Project	IEEE 802.16 Broadband Wireless Access Working Group < http://ieee802.org/16 >	
Title	Proposed Revision to Section B.3.2 (SC2 PHY Link Budget Analysis)	
Date Submitted	2002-05-02	
Source(s)	Anader Benyamin-Seeyar Harris Corporation Inc. 3 Hotel de Ville Dollard-des-Ormeaux, Quebec, Canada, H9B 3G4	Voice: (514) 845-8850 Fax: (514) 871-4859 mailto: abenjamin@sympatico.ca
	Remi Chayer	rchayer@harris.com
	Malik Audeh	malik.audeh@hybrid.com
	John Langley	john@alacritynetworks.com
Re:	Proposal to revise Section B.3.2 of document IEEE P802.16a/D3-2002 with provided text.	
Abstract	The Link budget analysis given in Tables 286 and 288 are being revised in Section B.3.2 of document IEEE P802.16a/D3-2002. This contribution provides more link budget results for various channel models introduced to IEEE802.16a as SUI model with Categories A, B, and C.	
Purpose	Incorporate provided text as revision of Section B.3.2 of document IEEE P802.16a/D3-2002.

Revision of SC2 PHY Link Budget Analysis

B.2.4 SC2 PHY LINK Budget Analysis

Figure 242—Path loss model for 30 m BTS antenna height (Categories A, B, & C)

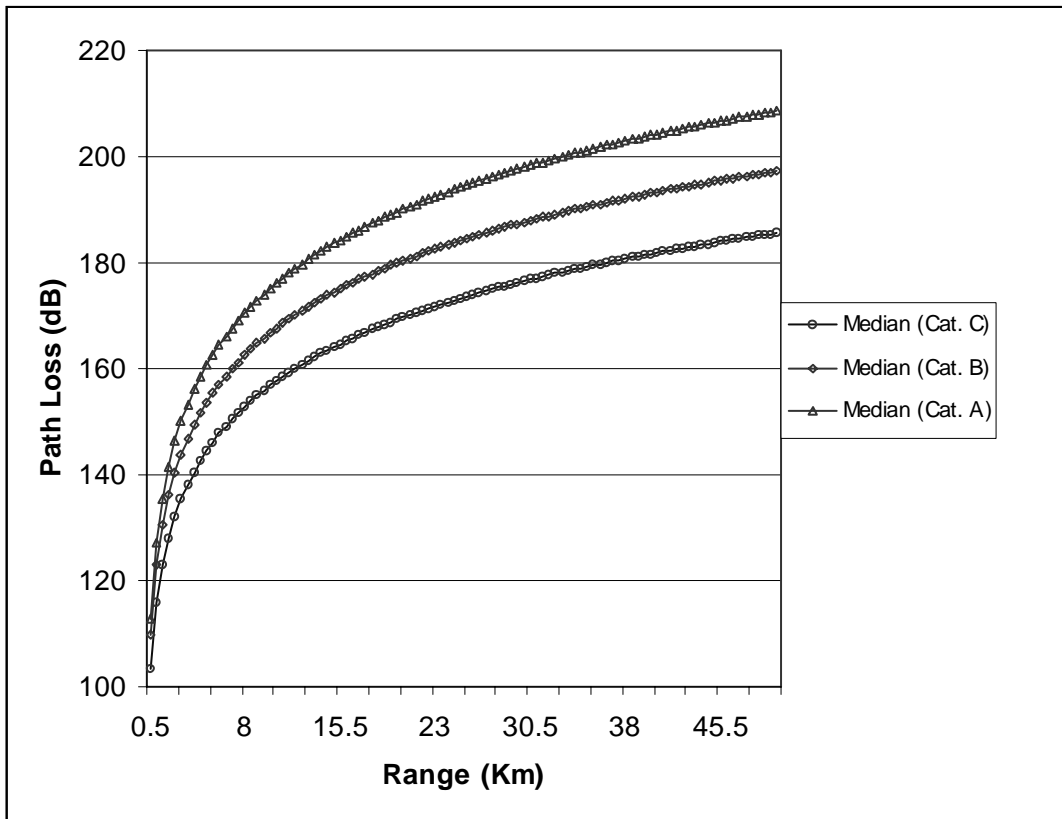
A link budget analysis was performed by combining various channel bandwidths and QAM constellations with the channel models found in [B48]. Figure 242 and Figure 243 provide two examples of the path loss versus propagation radius, using the NLOS Categories A, B, and C propagation models of [B48], and assuming 3.5 GHz band operation, a 6.5 m SS antenna height, and for a 30 m and 80 m BTS antennas height, respectively. For reference, an example set of parameters that fully specify channel model Categories A, B, and C in [B48] are listed in Table 286.
